Official Transcript of Proceedings
NUCLEAR REGULATORY COMMISSION

Title: Advisory Committee on Reactor Safeguards ABWR
 Subcommittee

Date: Tuesday, June 8, 2010

Chapter 19

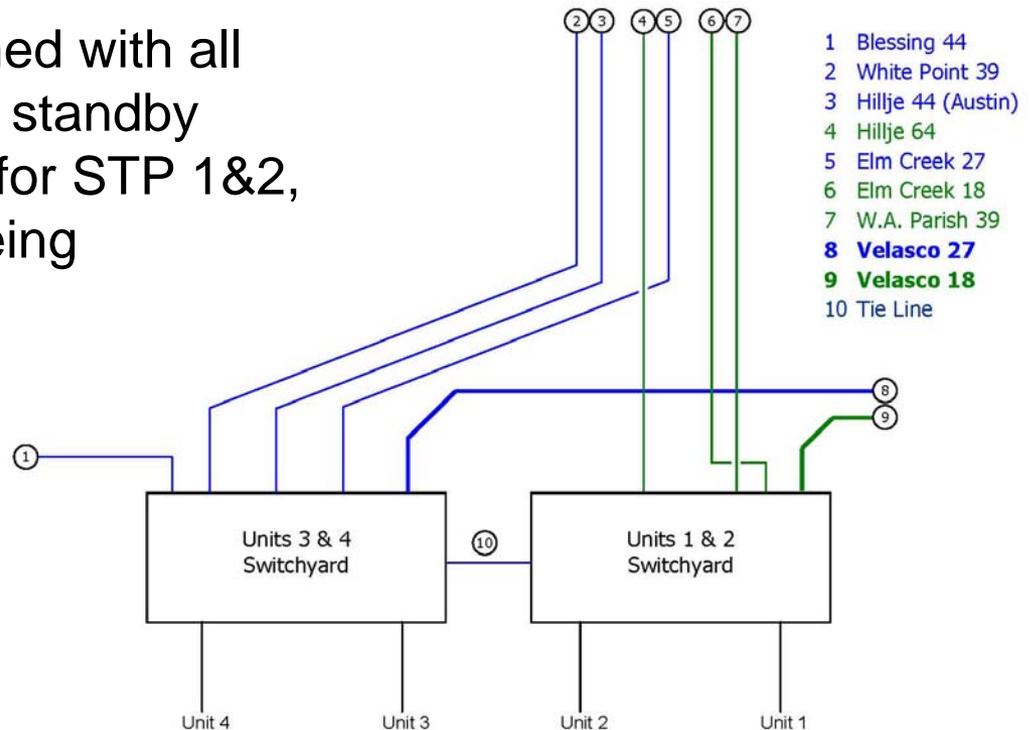
Confirm that the east offsite transmission lines (Velasco) are capable of supplying power to all four units' safety loads when other lines are lost.

Response: The east offsite transmission lines (Velasco) can provide power to all four units.

The load analysis was performed with all four units offline and the entire standby switchyard load (60 MW each for STP 1&2, 100 MW each for STP 3&4) being supplied by the respective circuit of the Velasco line.

Switching logic for the loss of a UAT electrical transient:

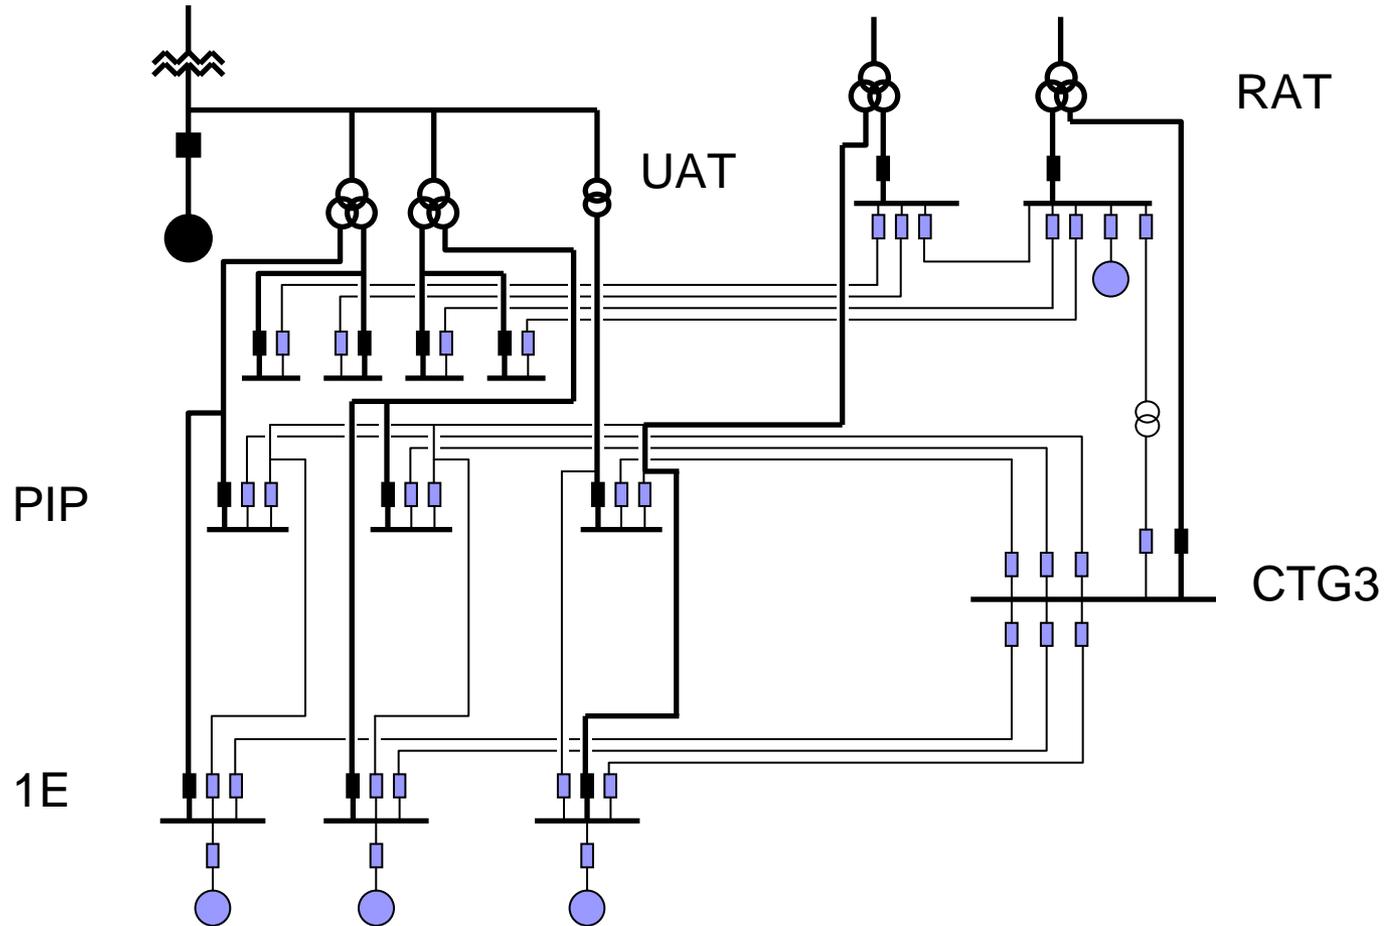
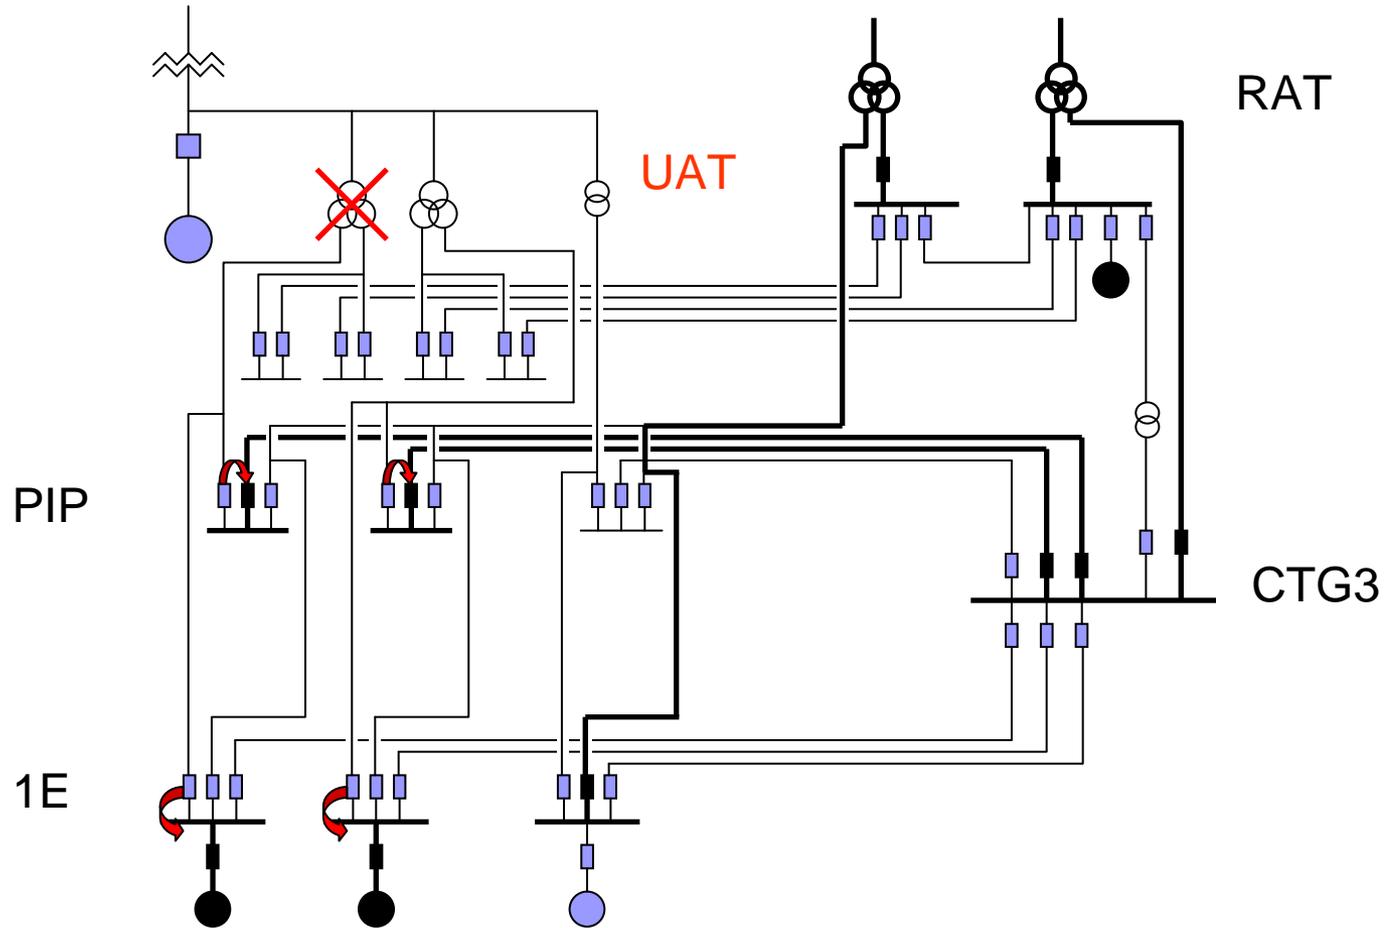
Performance of switching logic under various electrical transients.

Response: For the loss of a UAT:

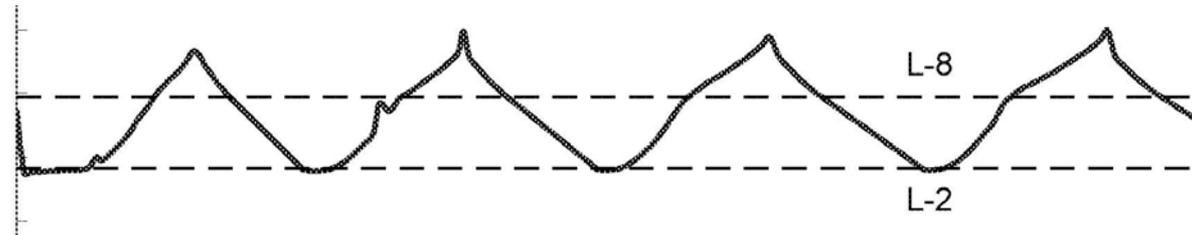
RAT 4.16 kV winding capability to feed two PIP buses and one safety bus.

Response: Two PIP buses and one safety bus (1E) can be supplied from the 4.16 kV winding for RAT B directly connected to bus CTG3, as well as from the RAT A or B 13.8 kV winding via CTG1 to CTG3.
